ADDISON AIRPORT - PARKWAY REALIGNMENT

Addison Airport - Parkway Realignment

2004

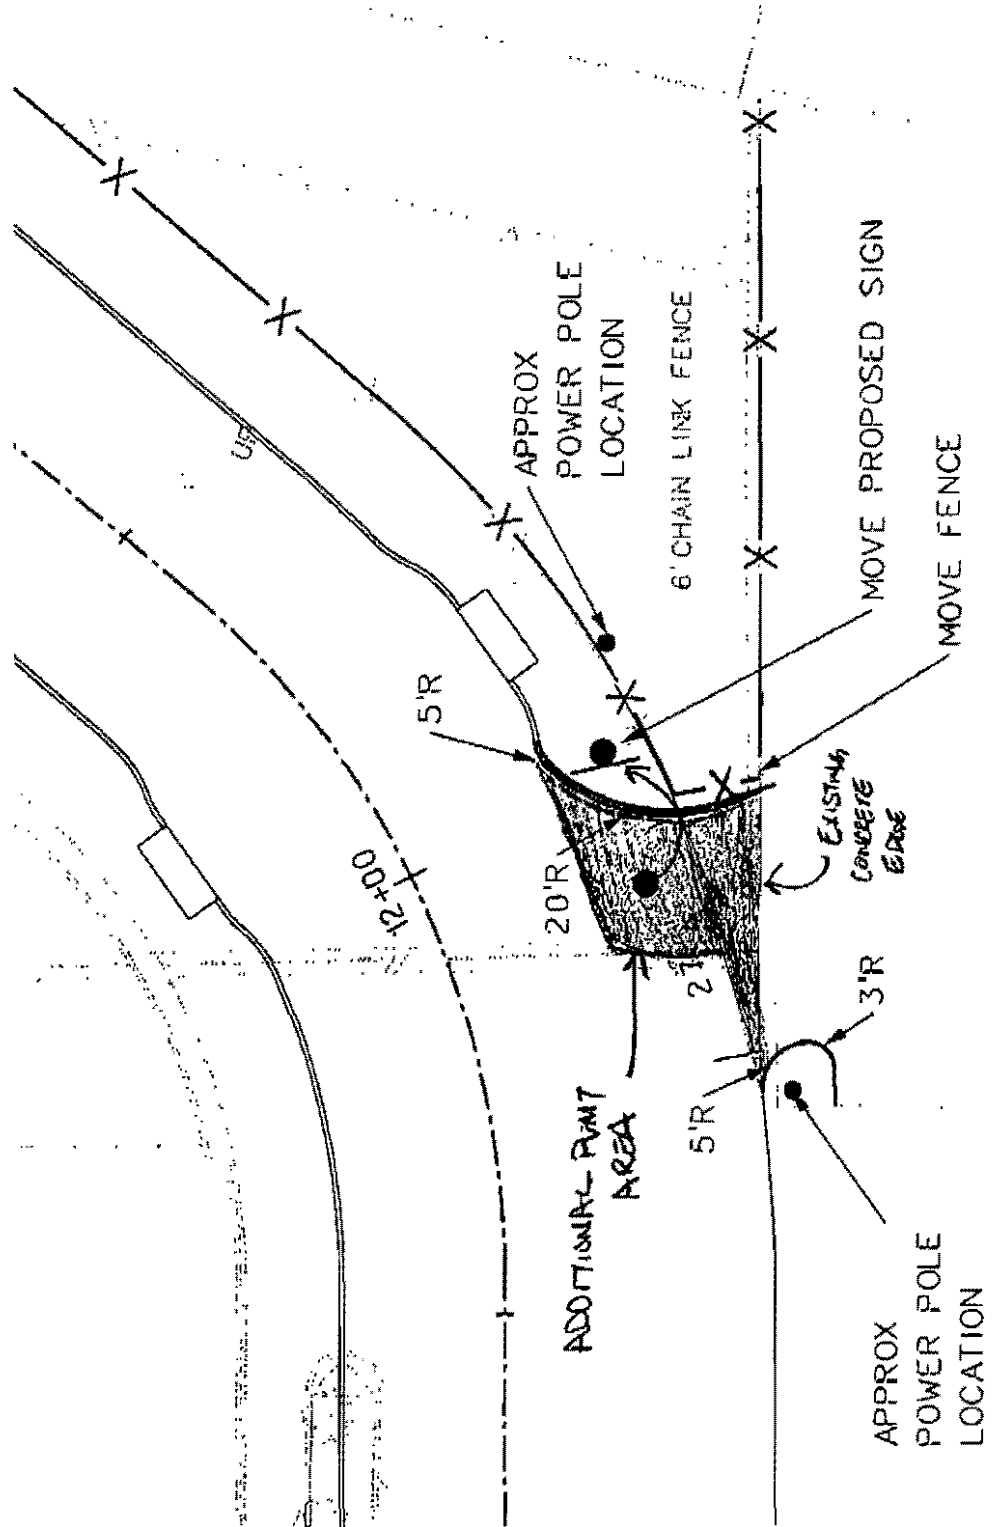
I am sending along a drawing showing a proposed entrance onto Omni Flights Property. This is to be used to direct you where the entrance will be located. I will fax over more detailed drawings in the morning. This issue came up this afternoon and I wanted to send this over as soon as possible so that you were aware of the situation.

Please note that the both the proposed sign and fence location will need to be modified per this entrance layout. There is approximately an addition 42 SY of pavement due to this entrance.

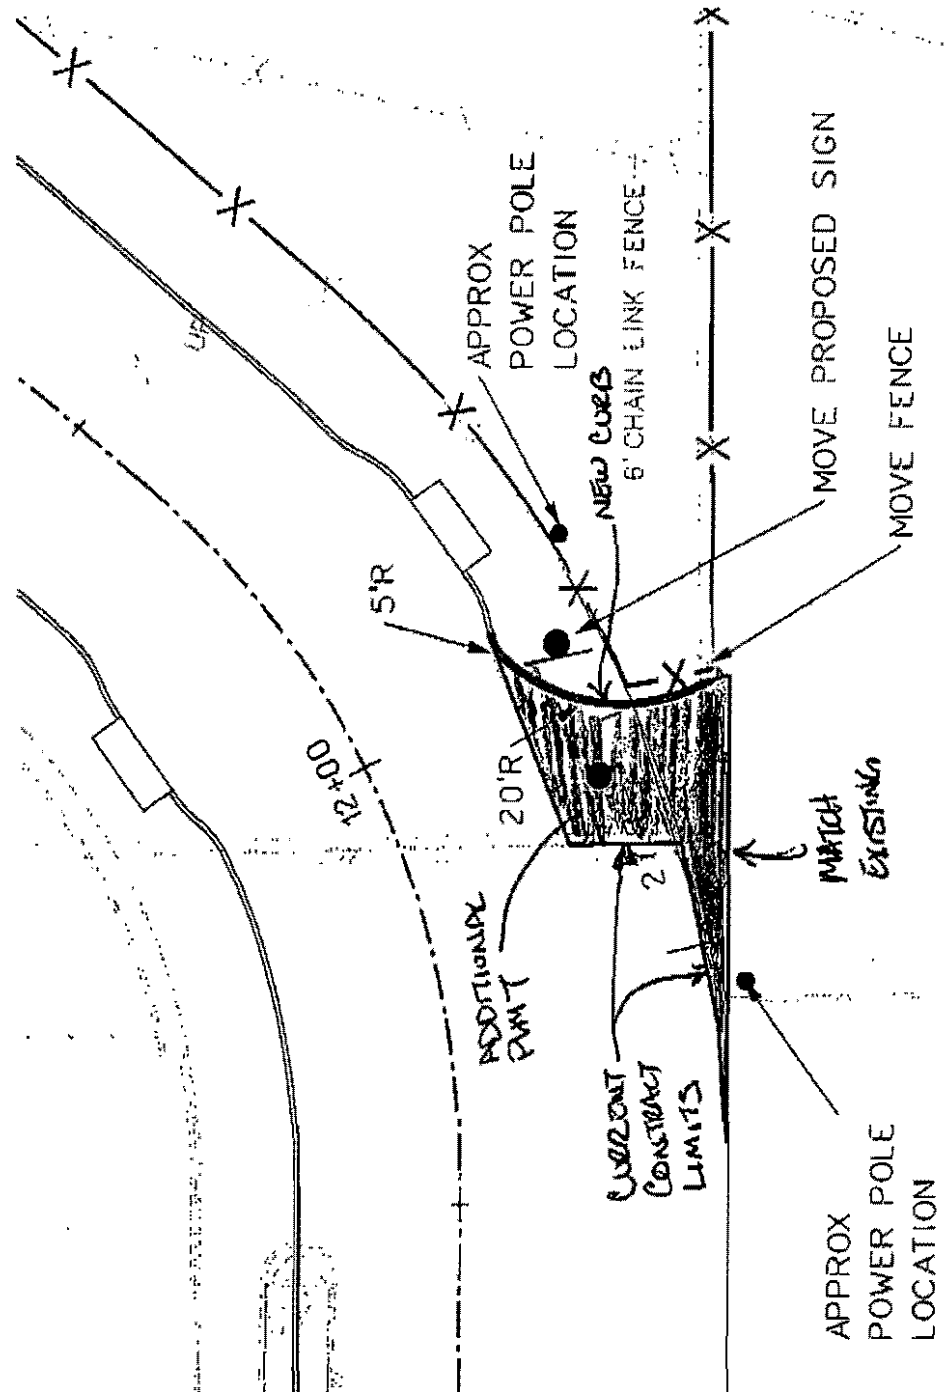
Revised drawing taking out the 5'R curb on the west side
